UK Offshore Energy Strategic Environmental Assessment

OESEA3

Consultation Feedback

UK OFFSHORE ENERGY STRATEGIC ENVIRONMENTAL ASSESSMENT (SEA): ENVIRONMENTAL REPORT CONSULTATION

Chart 1 Steps through the Habitats Directive (✓ plan or project can proceed; ✗ plan or project should not proceed)

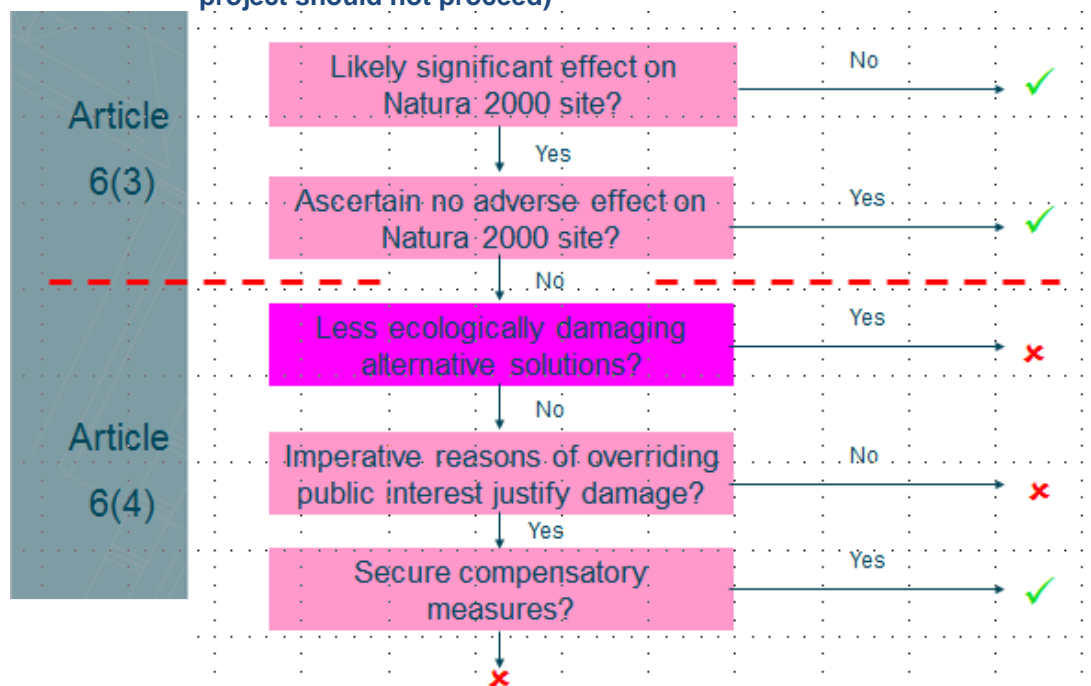
Article 6(4) provides that if, in spite of a negative assessment of the implications for the site, and in the absence of alternative solutions, the plan or project must nevertheless be undertaken for imperative reasons of overriding public interest (IROPI), the Member State will take all compensatory measures necessary to ensure that the *Natura 2000* network is protected (this process is illustrated in the flow chart below).

Hence even in those circumstances where an adverse effect on site integrity is determined, if no alternative solutions and IROPI can be demonstrated and compensation provided, then the development could proceed within a European designated site.
